**Addendum No. 1**

**August 28, 2025**

**City Project No.: 23-069**  
**Roads Program Capital Improvement Project**

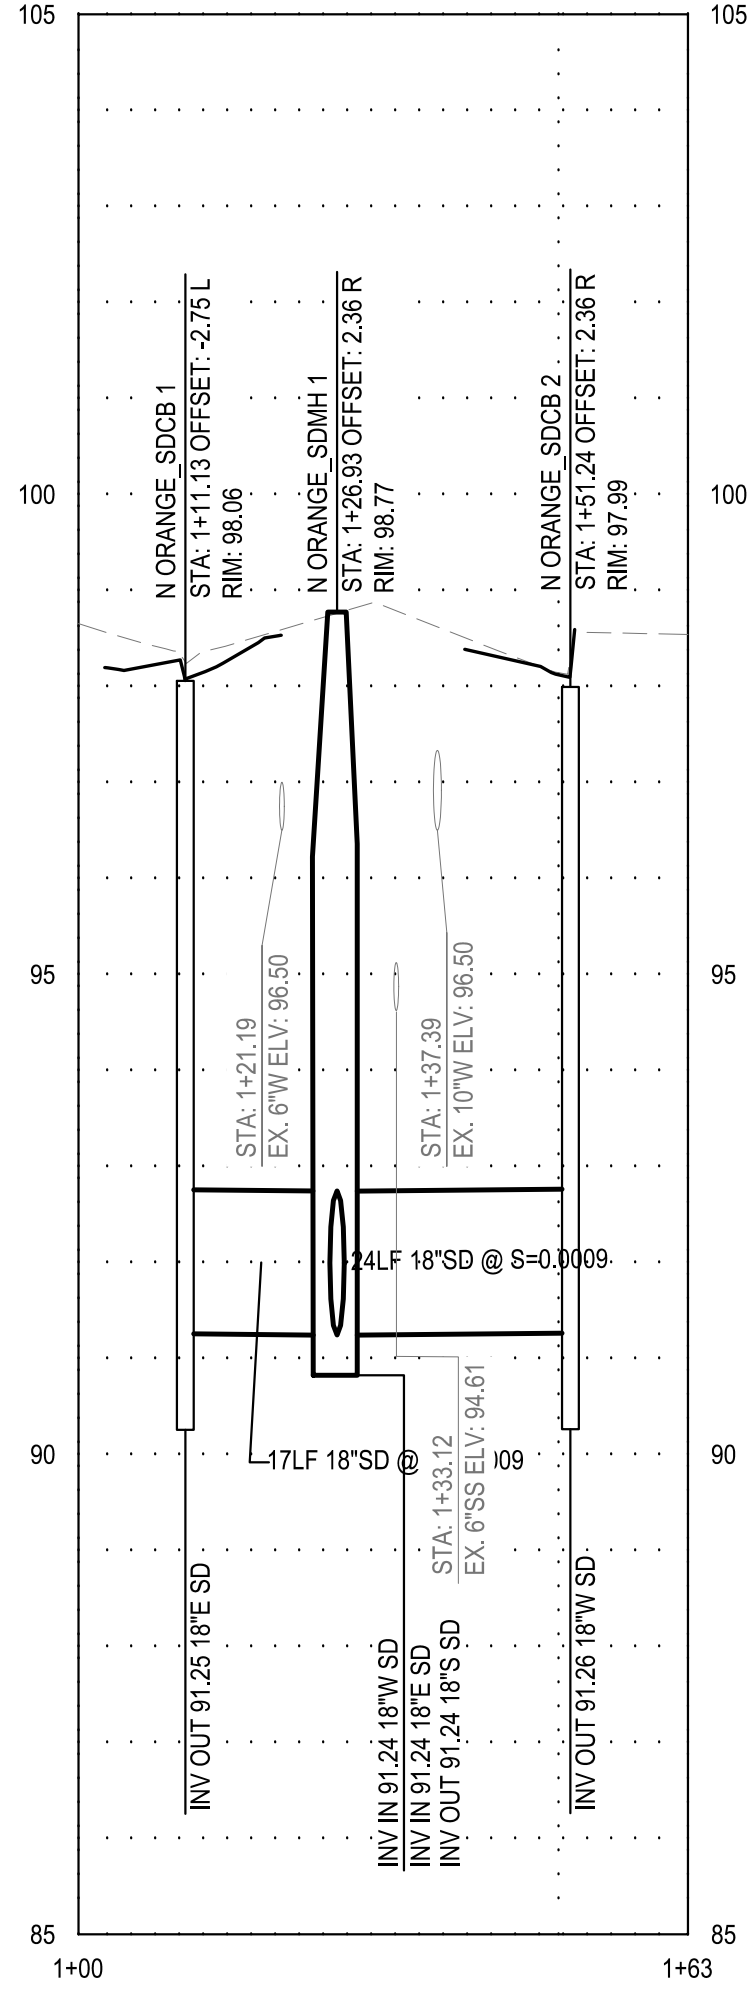
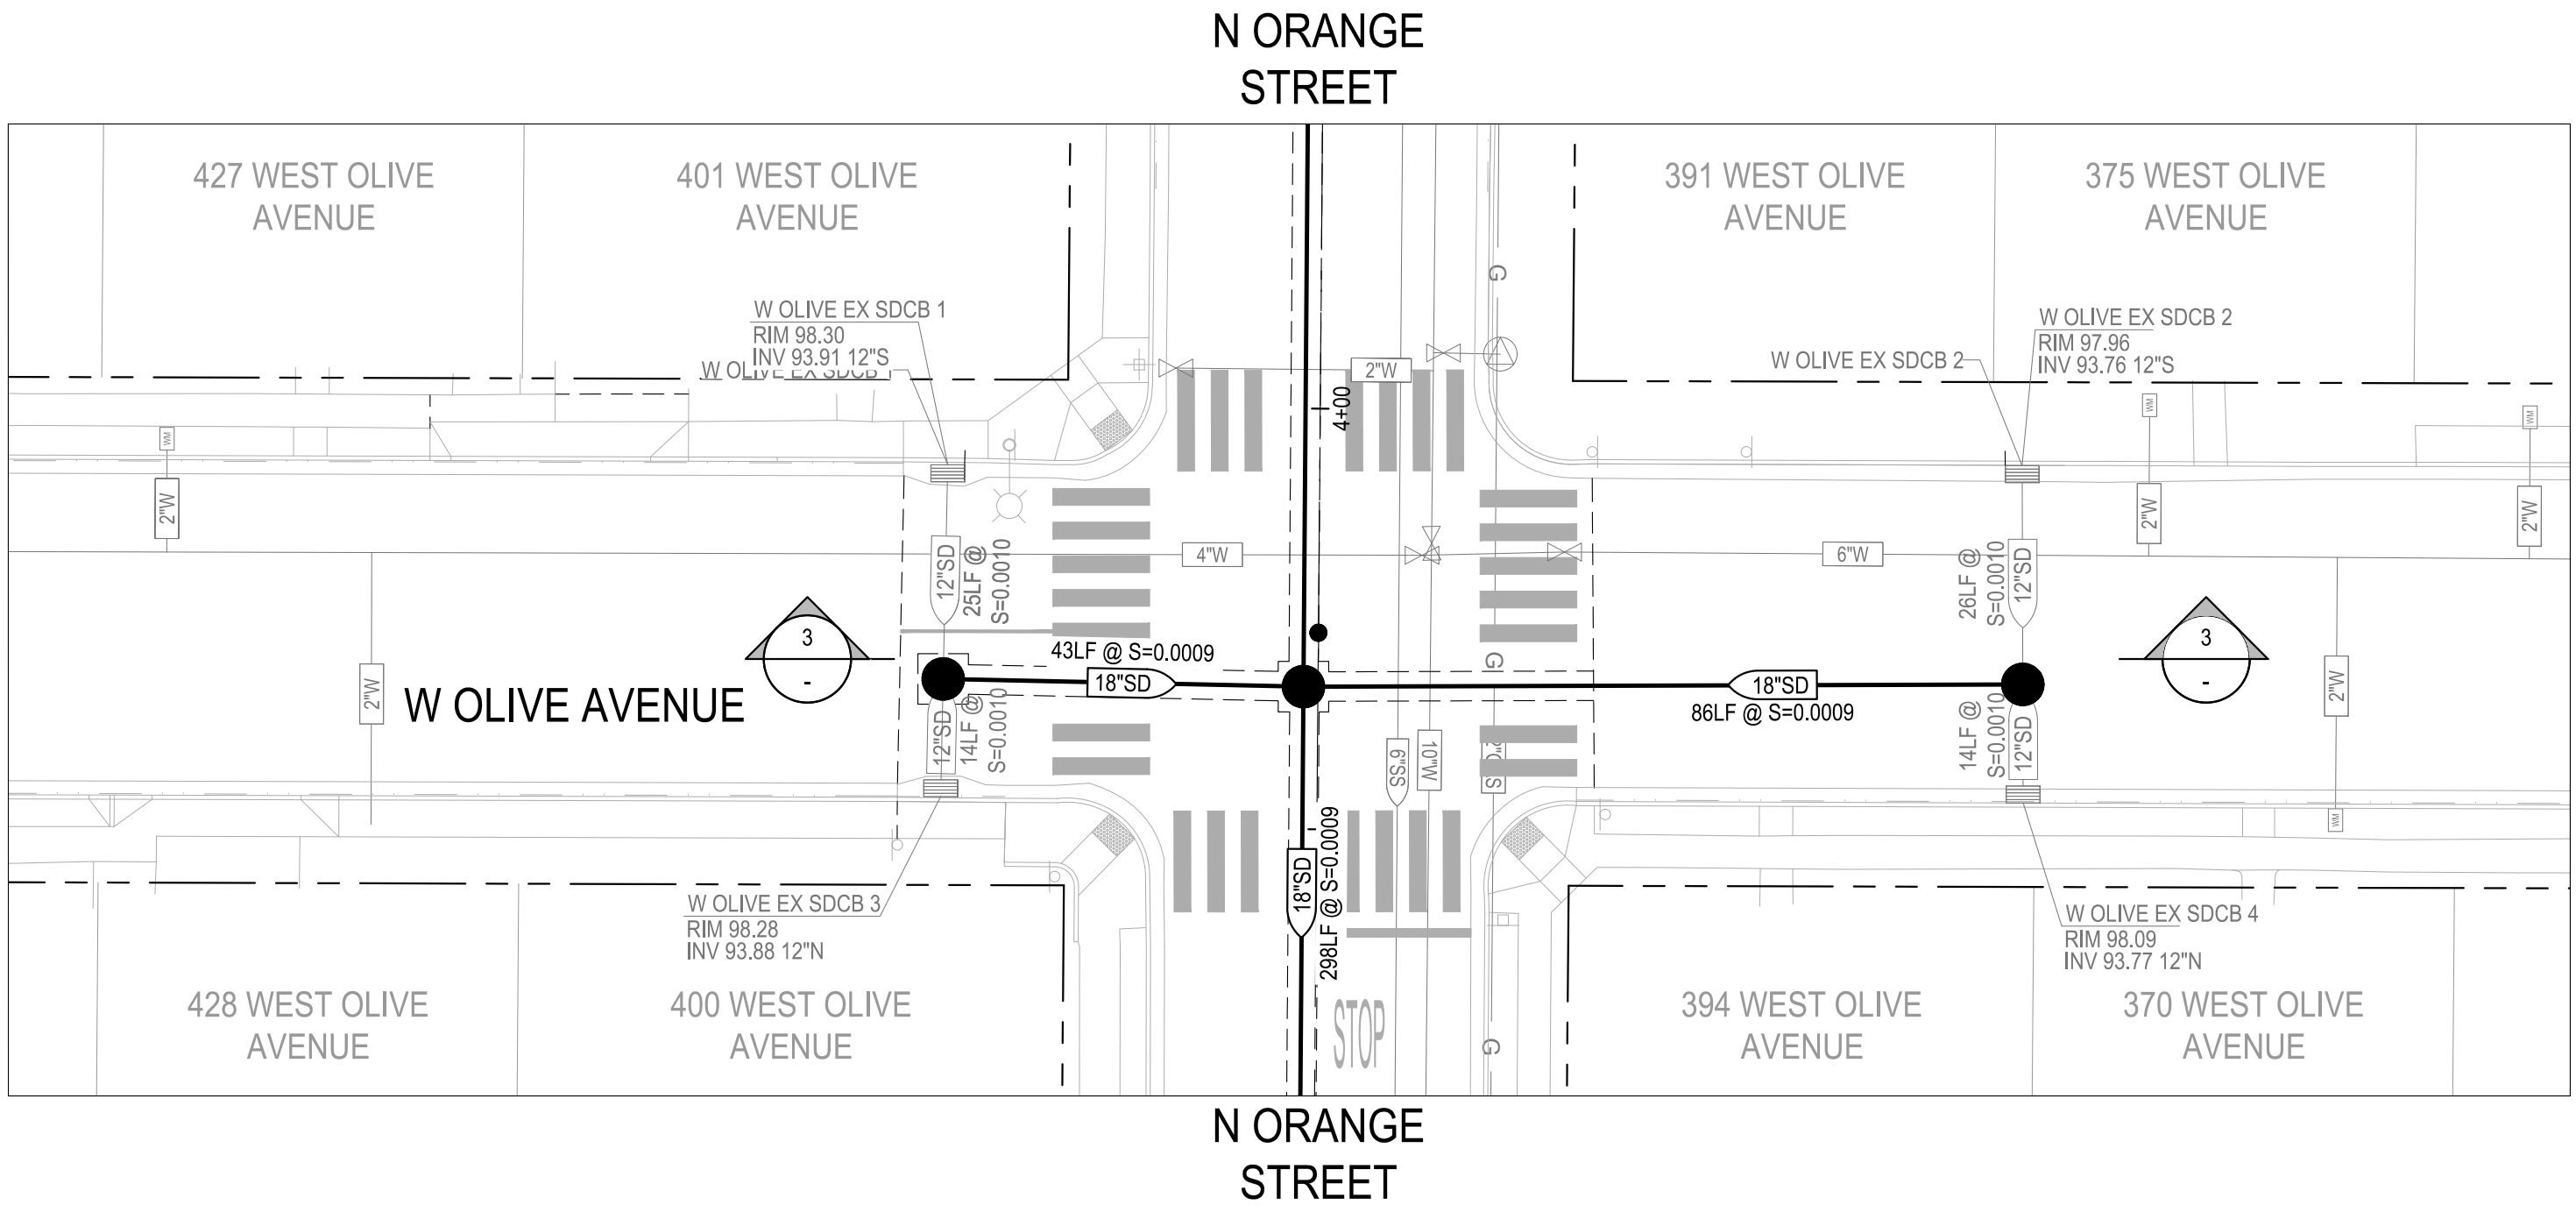
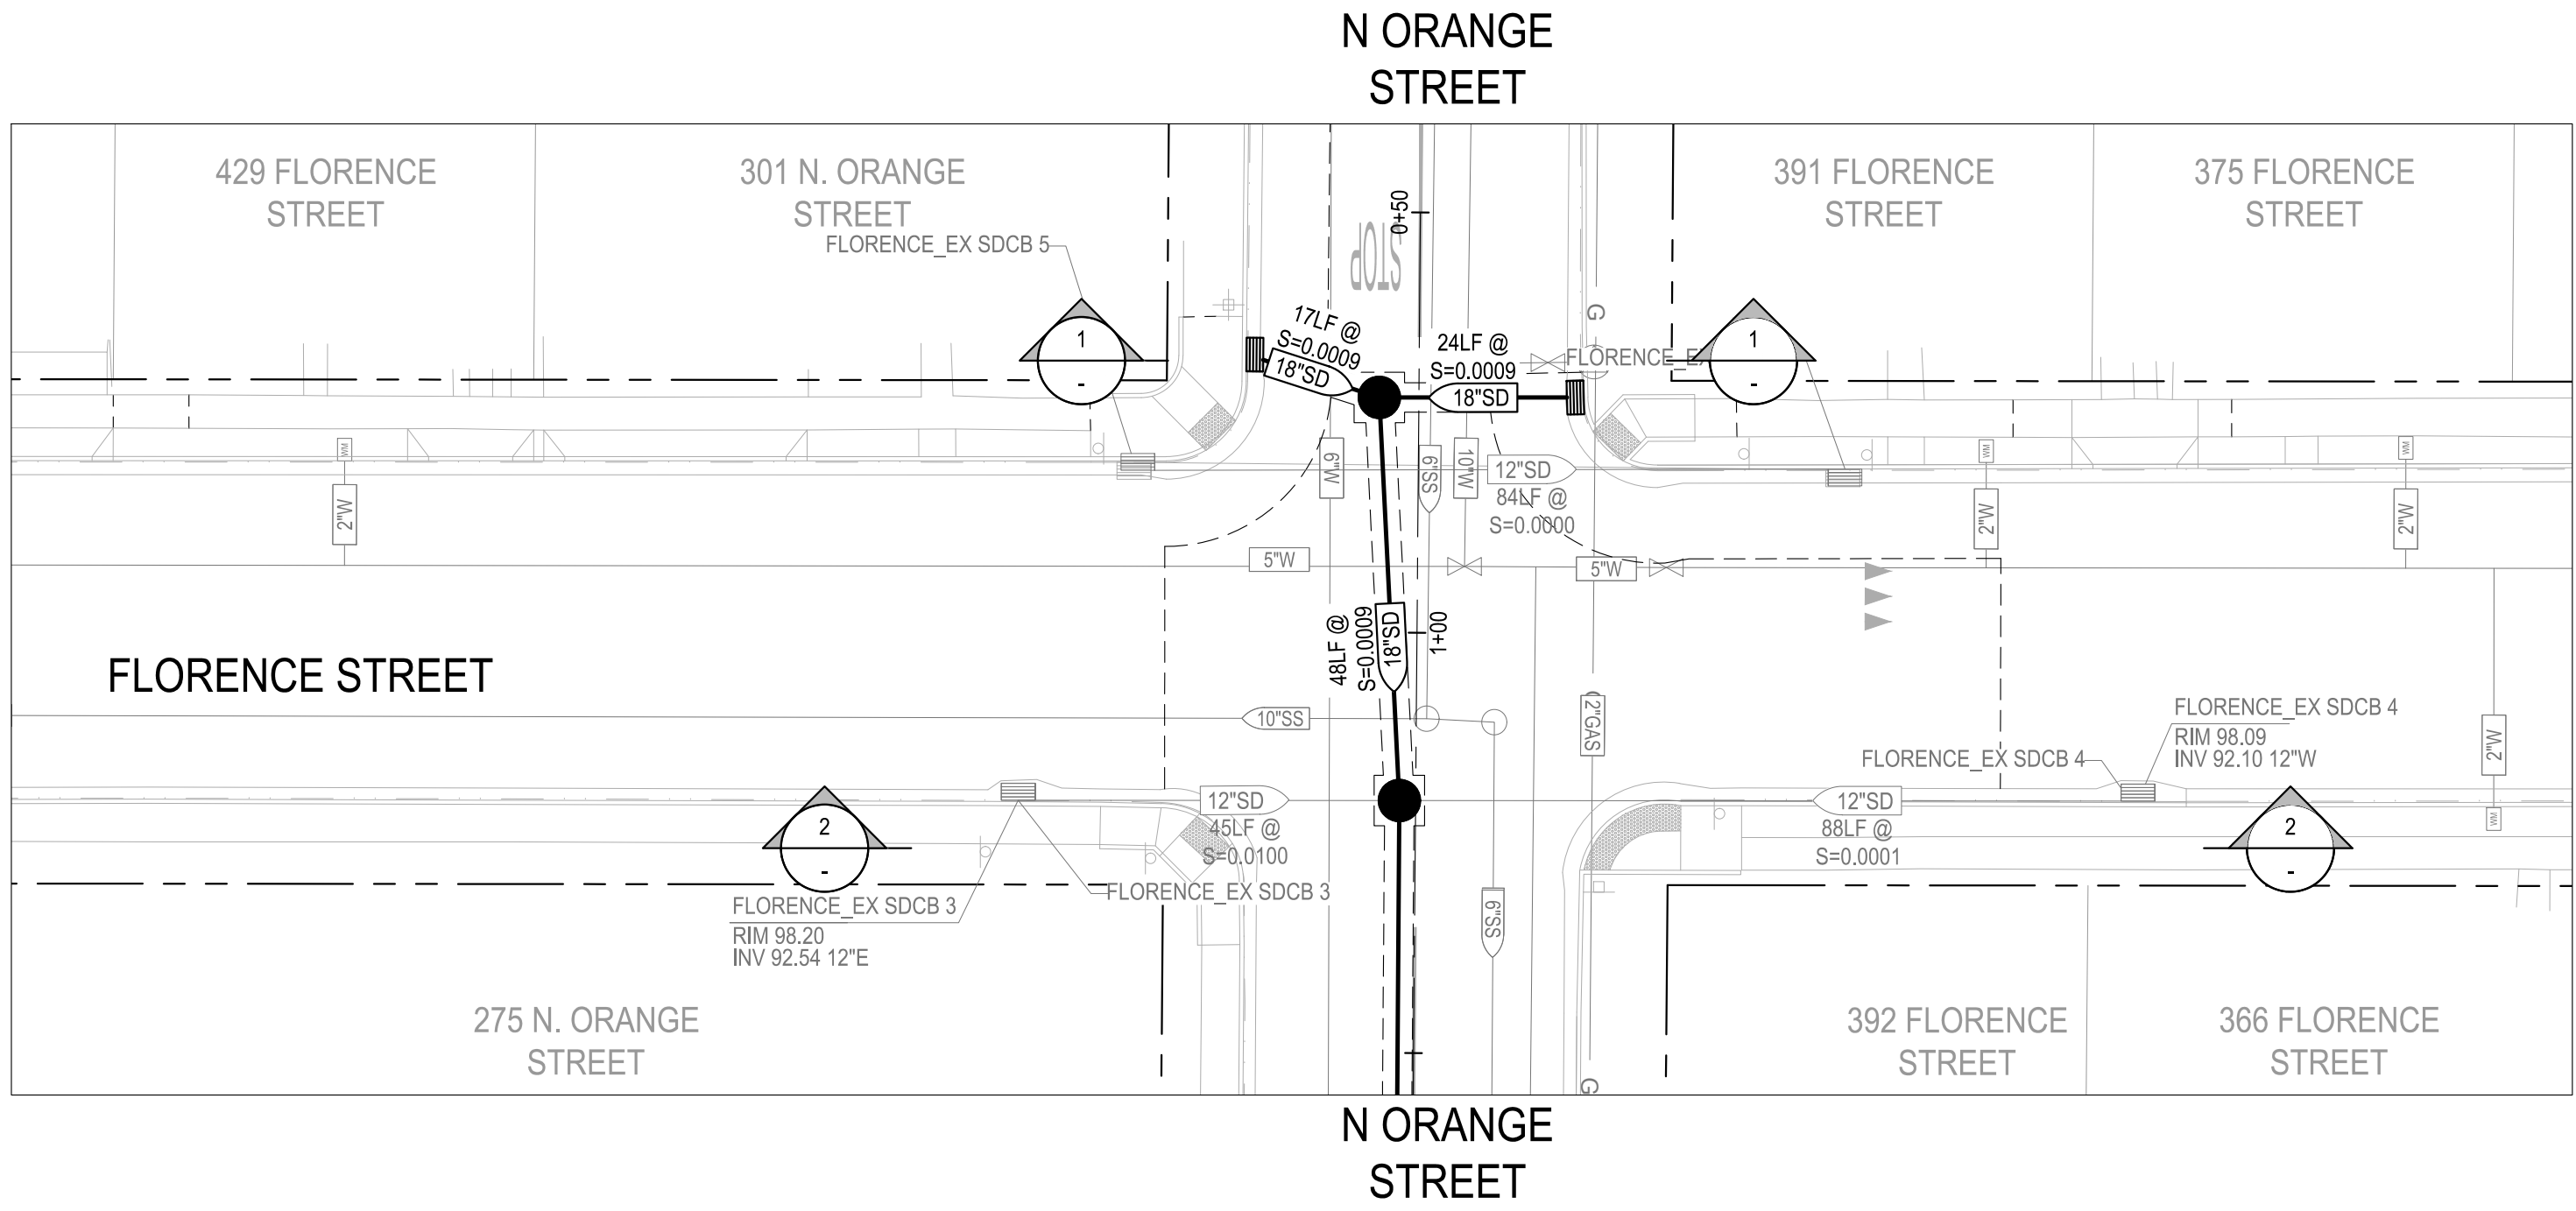
Sheet 51, Keynote 2 was added to Stripe 50' of Detail 22 on N Orange Street.
